Docket Number:	15-BSTD-05
Project Title:	2016 Nonresidential Compliance Manual and Documents
TN #:	205933
Document Title:	Davor Novosel Comments: On Acceptance Test Requirements
Description:	N/A
Filer:	System
Organization:	Davor Novosel
Submitter Role:	Public
Submission Date:	8/31/2015 11:08:48 AM
Docketed Date:	8/31/2015

This comment concerns Acceptance Test Requirements “NA7.5.1 Outdoor Air: Variable Air and Constant Volume Systems, 2016 Nonresidential Compliance Manual DRAFT, pages 13-38, 13-44 and 13-45. The proposed changes are indicated on the attached pdf-files excerpted from the said NRC Draft document.

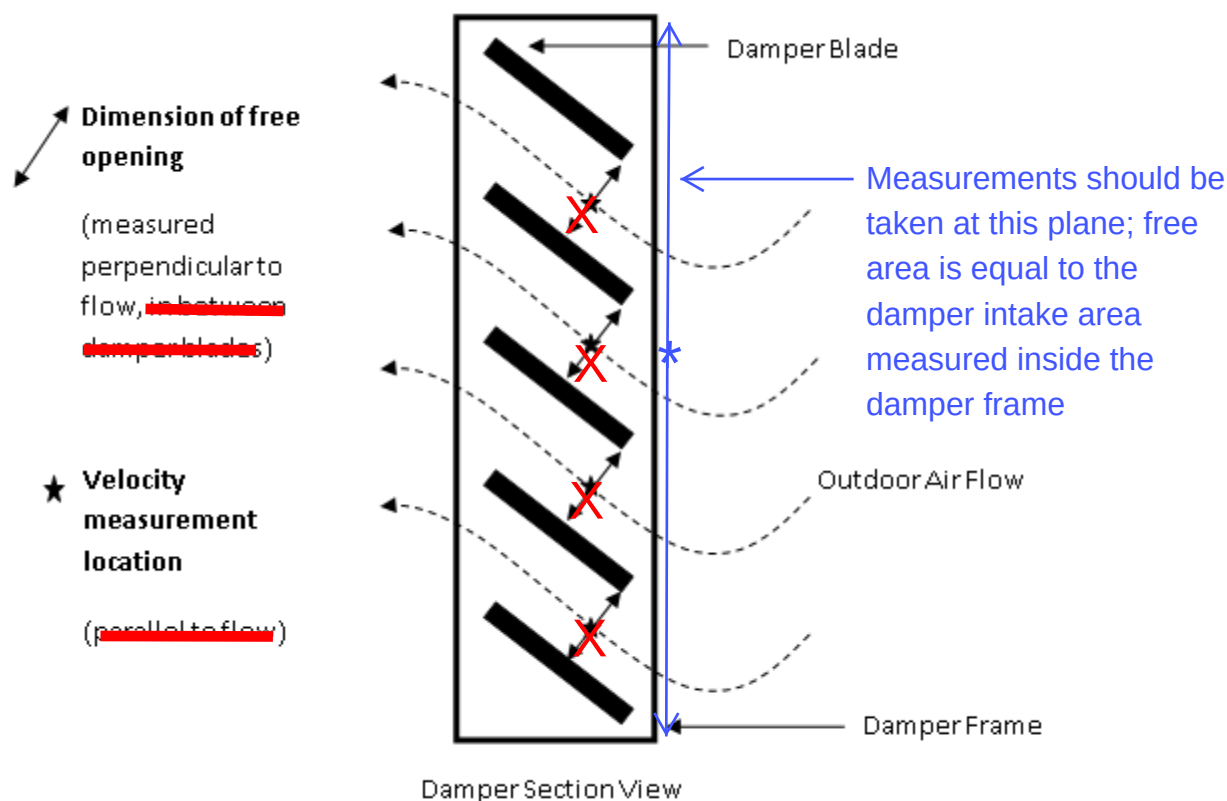
- ~~If~~ When velocity measurements are taken ~~at the plane of the intake between damper blades where flow is restricted (i.e. to achieve faster flows), free area should be measured as the actual open space between dampers and should not include frames or damper blades.~~ See diagram below for illustration of free opening measurements.

- Hot wire anemometers are more appropriate than velocity pressure probes for measuring low speed flows (i.e. less than 250 feet per minute). When measuring flow with a hot wire anemometer, make sure to position the measurement device ~~such that it is perpendicular to flow direction of flow.~~

- Take multiple measurements and average results in order to minimize ~~affects~~ effects of fluctuations in system operation and environmental conditions (i.e. wind).

Your body can serve as an obstruction to air flow and ~~affect-effect~~ measurements. ~~To increase measurement accuracy,~~ Position your body away from the intake and flow of air.

Step 1: Disable demand control ventilation, when applicable.

Step 12: Disable the air economizer if when applicable and test at full supply airflow

~~If~~ When the system has an outdoor air economizer, force the economizer to the minimum position and stop outside air damper modulation.
